Sub: Flash SIM Fallout

RESULTS OF APPLE FLASH SIMM EVALUATION

title 'FLASH GORDON III JW UPGRADE FOR POWER SEQUENCING'

(ROM SIMM Connectors - next page)
SIMM Isolation Switch Circuitry
Control PAL

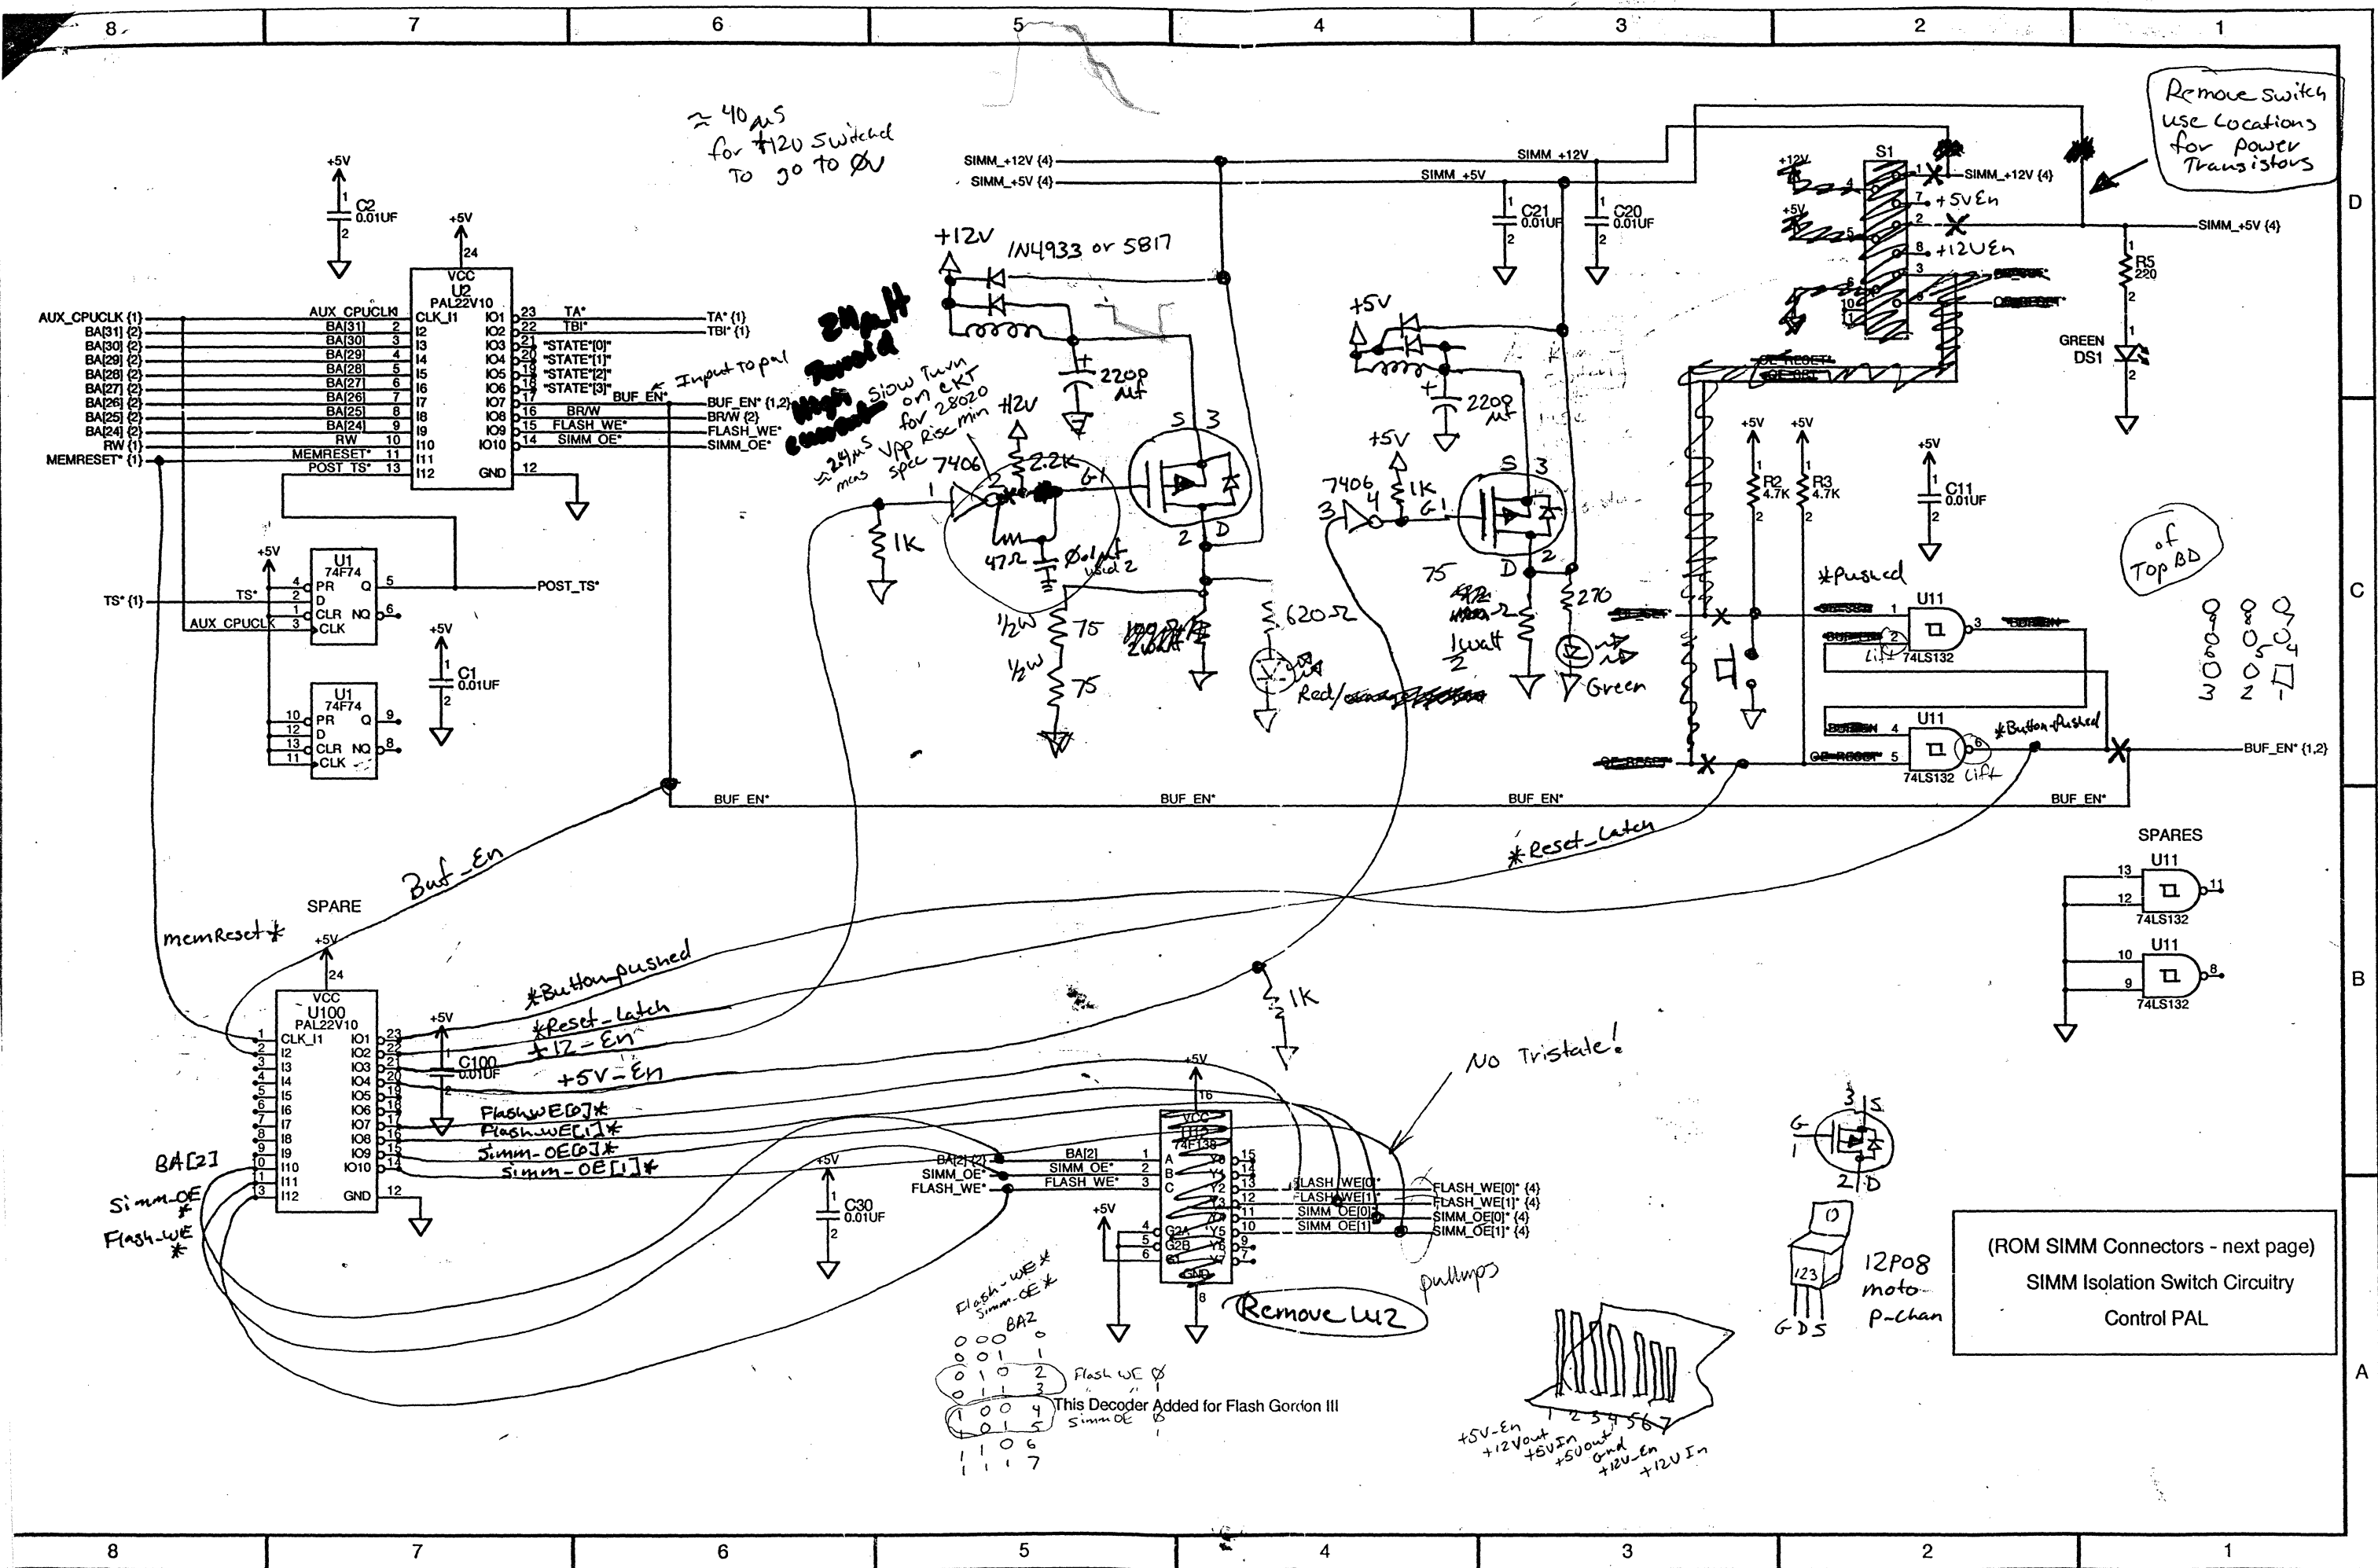
This Decoder Added for Flash Gordon III

V_{pp}

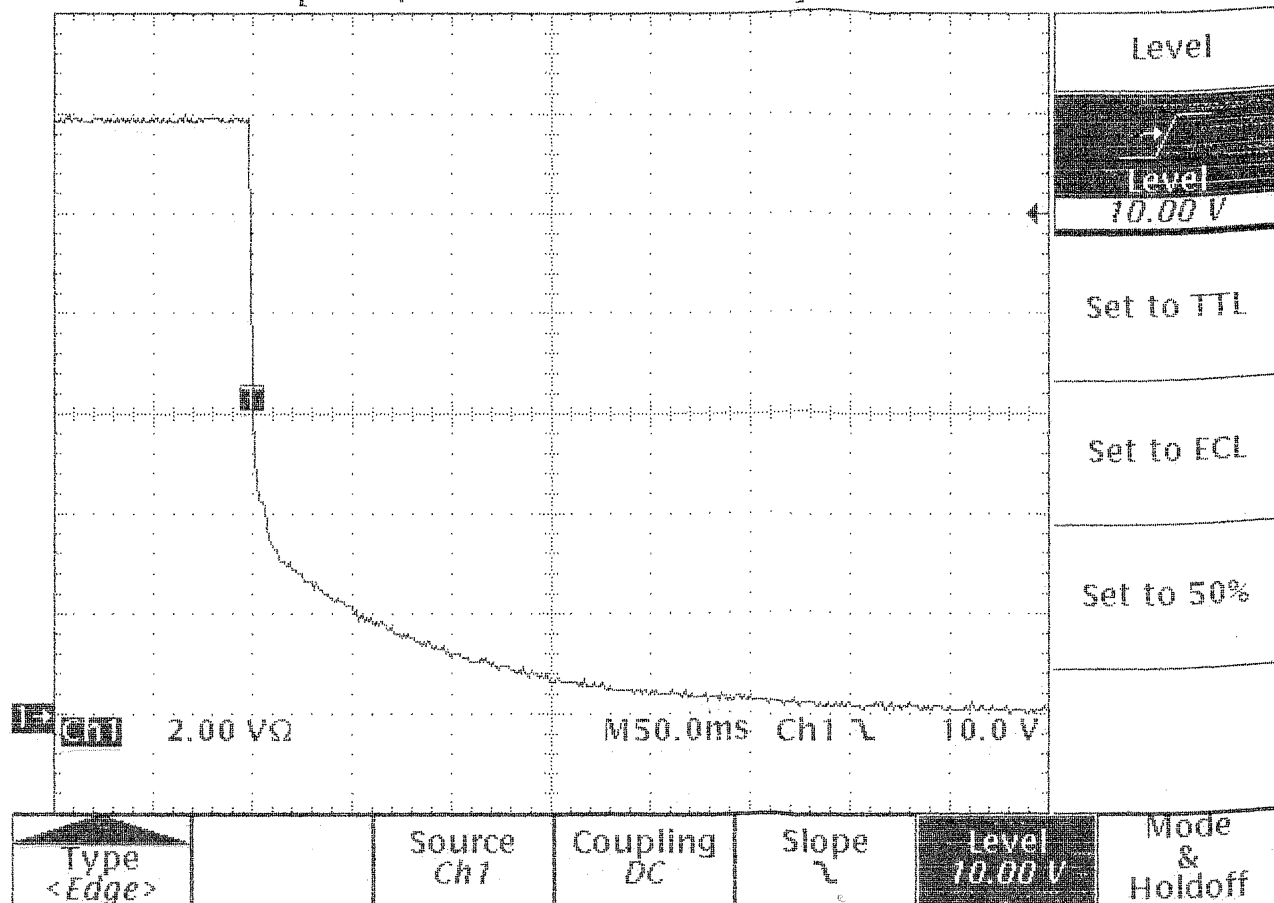
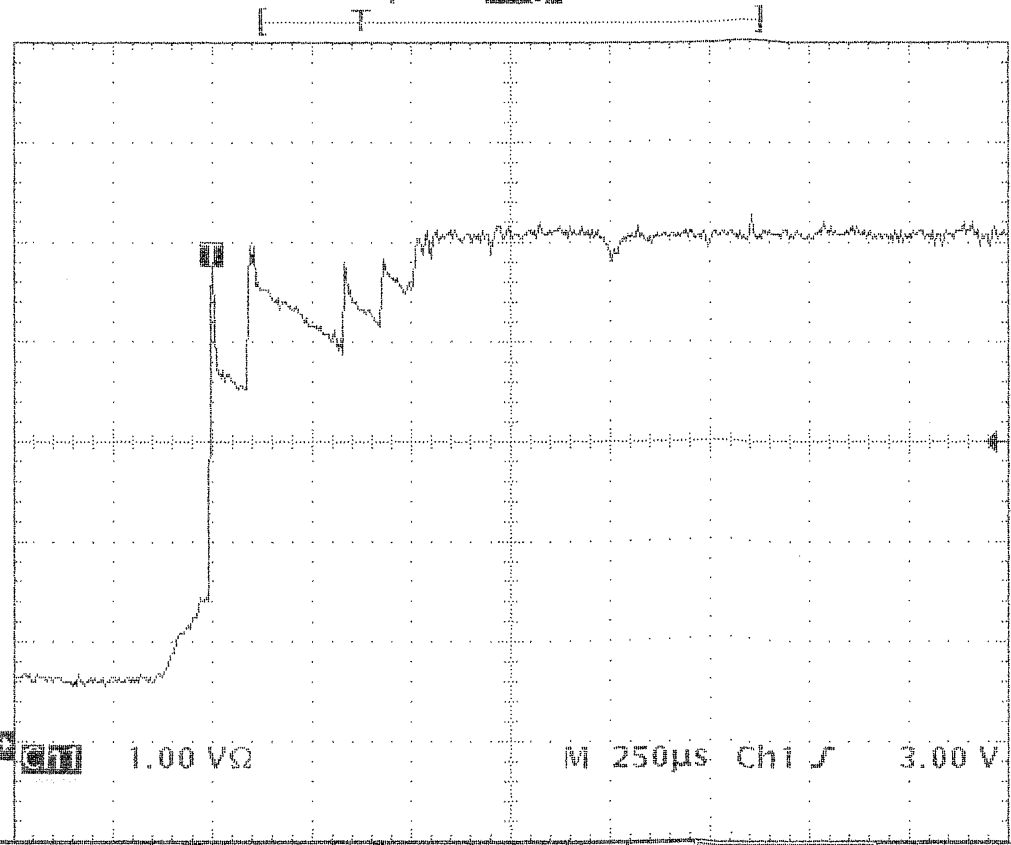
V_{DD}
(never goes to ϕV)
